Metro Inner Development Assessment Panel Agenda

Part B – Item No.4.1

Lot 100 (Nos. 40-44) Worley Street, Willagee

RESPONSIBLE AUTHORITY REPORT – FORM 2	
DAP File No:	DAP/25/03006
LG Reference:	DAP-2025-9/A
Approved Development	41 Multiple Dwellings
Proposed Amendments:	Removal of six (6) units and other minor modifications to accommodate.
Owner:	Alchera Living (Inc)
Applicant:	Gary Batt, Gary Batt & Associates
Local Government Area:	City of Melville
Responsible Authority:	City of Melville
Authorising Officer:	Kate Bainbridge – Manager Development Approvals
Date of Original DAP decision:	16 June 2026
Date(s) of previous amendments:	N/A
Application Acceptance Date:	24 September 2026

Figure 1: Floor Plan Elevation Comparison

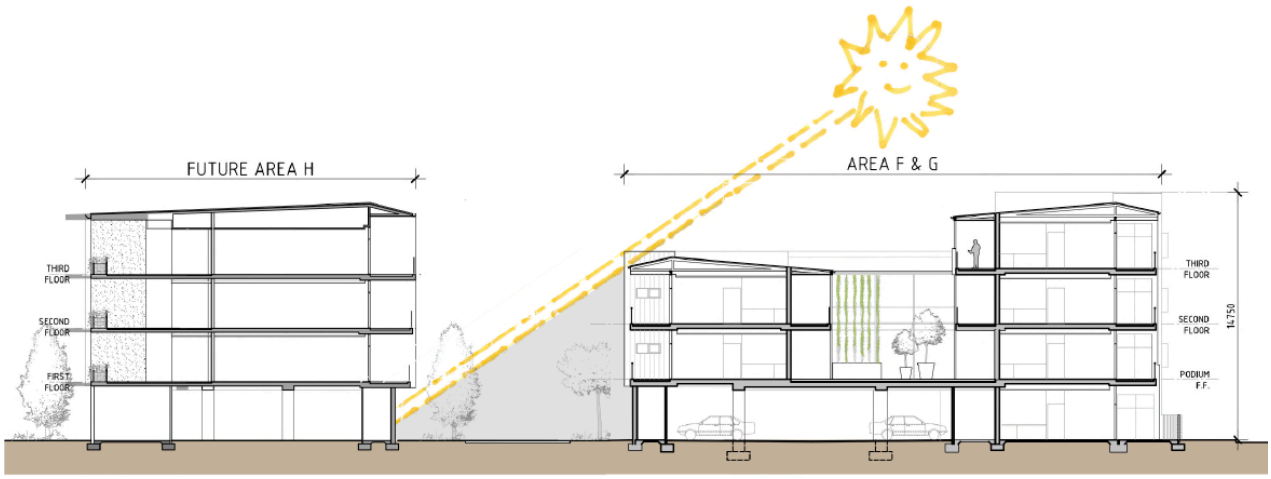
Proposed Modified Third Floor Plan

Approved Third Floor Plan

1. The proposed height reduction to the southern portion of the building will help improve the streetscape outcome on Worley Street through reduce building bulk forward of the building and will create visual interest in the street elevation.

Figure 3: Section Comparison

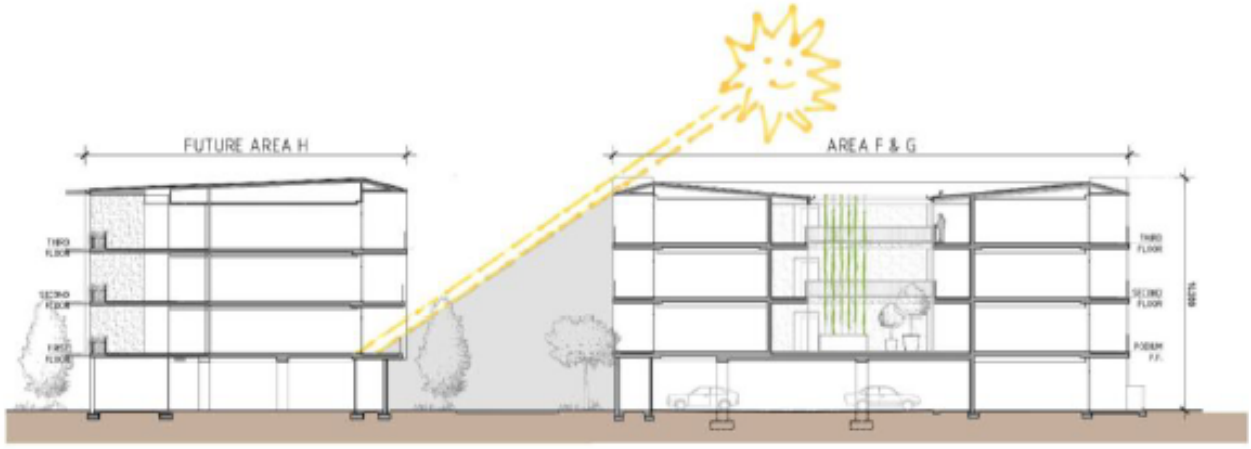
Section of Proposed Modified Development

Section of Approved Development

Importantly, the amended design provides improvements to the relationship of the development with its surrounding context, including reducing the southern portion of the building from four (4) storeys to three (3) storeys, offering improvements of building form and presentation to Worley Street and improving the interface with the future development anticipated on the southern portion of the site. The modifications respond positively to matters previously raised through the design review process, particularly in relation to building height, streetscape presentation and the interface between the development and the balance of the site.
